Explanation of Request: Request for site plan approval to construct a 7 story, 180 unit multi-family residential building with ground floor commercial.

Project: **Hollywood Mixed Use Apartments** 2233 Hollywood Boulevard, Hollywood, FL
File Number: 19-DP-57

Responses to Preliminary TAC Comments

DRAINAGE MAP (PRE-DEV. CONDITION)

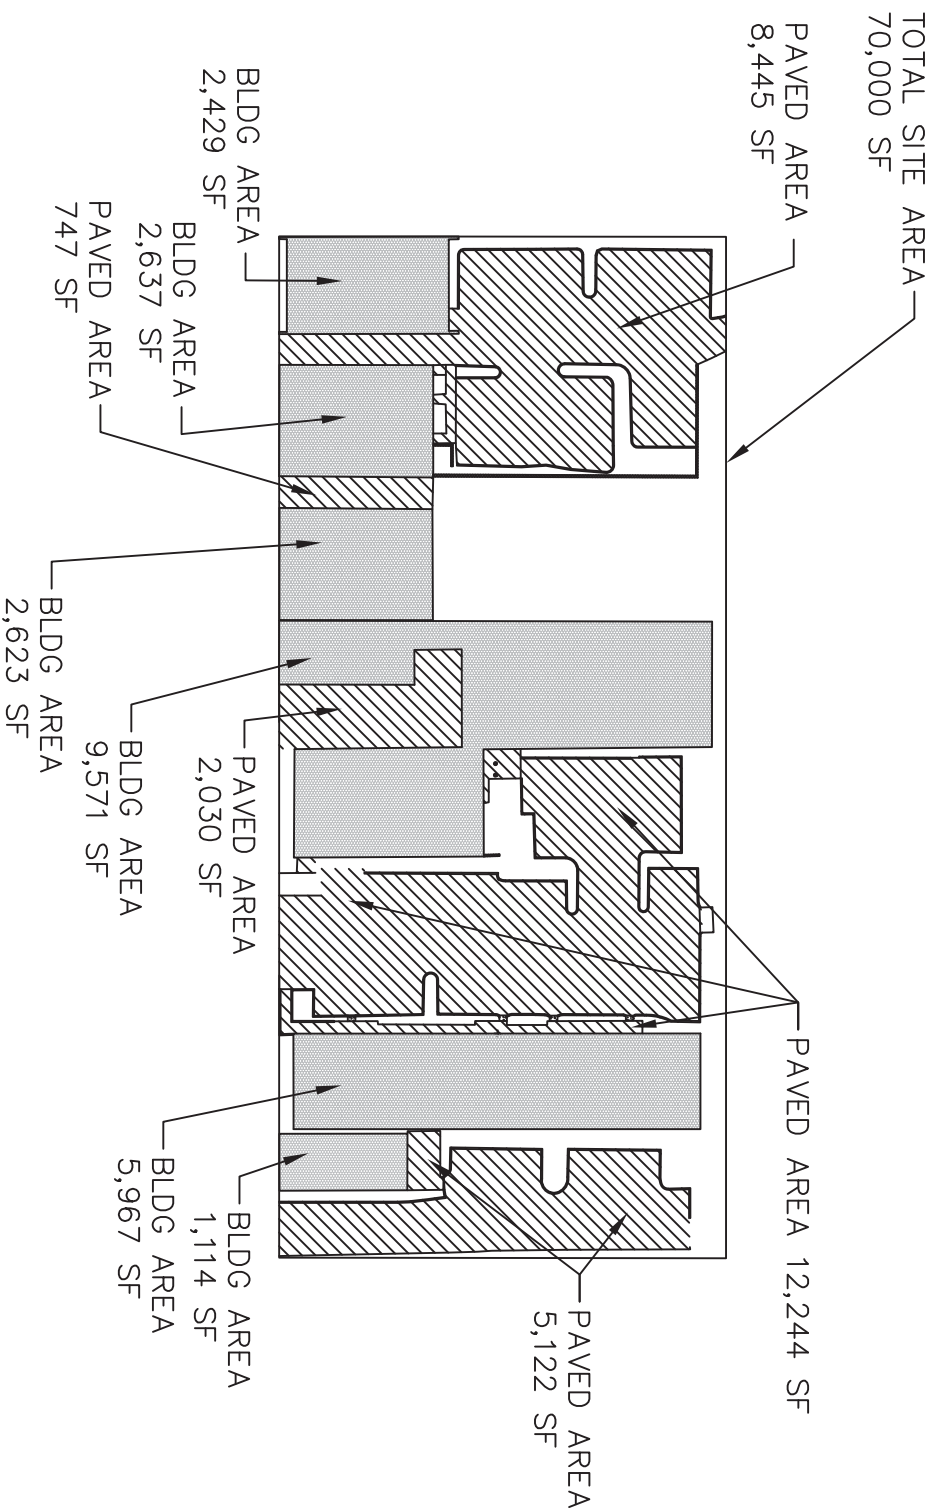
The drainage system uses an exfiltration trench system to retaining the entire runoff volume generated by the 5-year, 1-day storm on-site. Additionally, the system shall also provide water quality treatment for the first inch of runoff or 2.5 inches times the percentage of imperviousness, whichever is greater, and also make sure that post-development runoff doesn't exceed the pre-development runoff for the 25 year and the 100 year three day storm events.
